RESPONSE TO DP&E REQUEST FOR ADDITIONAL INFORMATION - MOD 1 TO MP09_0146 EASTLAKES SHOPPING CENTRE

This letter has been prepared by Urbis on behalf of Stateland East Unit Trust (The Applicant) regarding MP09_0146 Mod 1 – Modification to Eastlakes Shopping Centre Mixed Use Development.

Figure 2 – Western Elevation (Proposed)

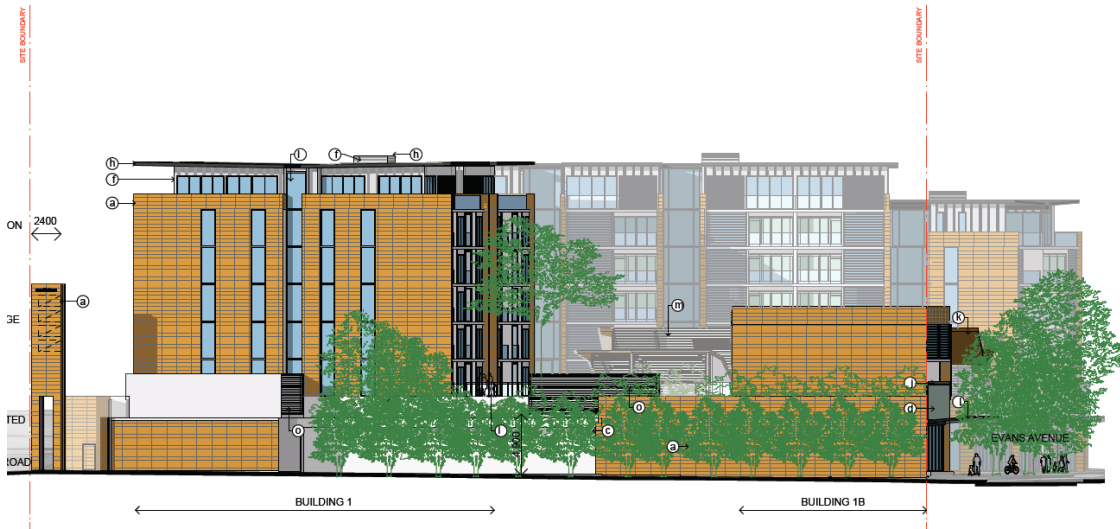
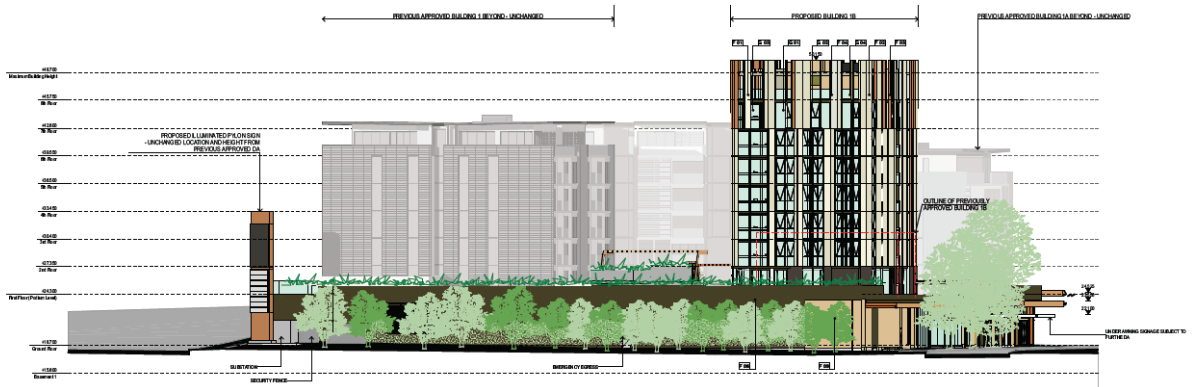
- **Western Elevation:** reinstate tree plantings along south-western setback at ground level to screen the wall behind.
- **Eastern Elevation:** increase landscaping to screen the 1.8m boundary wall.
- **Gardeners Road:** investigate ways to reduce the height of the 6m high 'unbroken' wall which results in an adverse urban design outcome.
- **Building 1B:** investigate reducing height of architectural roof feature.

The entire length of the western boundary setback at ground level now proposes planting of medium sized trees. These trees will screen the wall behind when viewed from the neighbouring property, consistent with the approved development. Refer to Figure 1 and 2 extract comparisons.
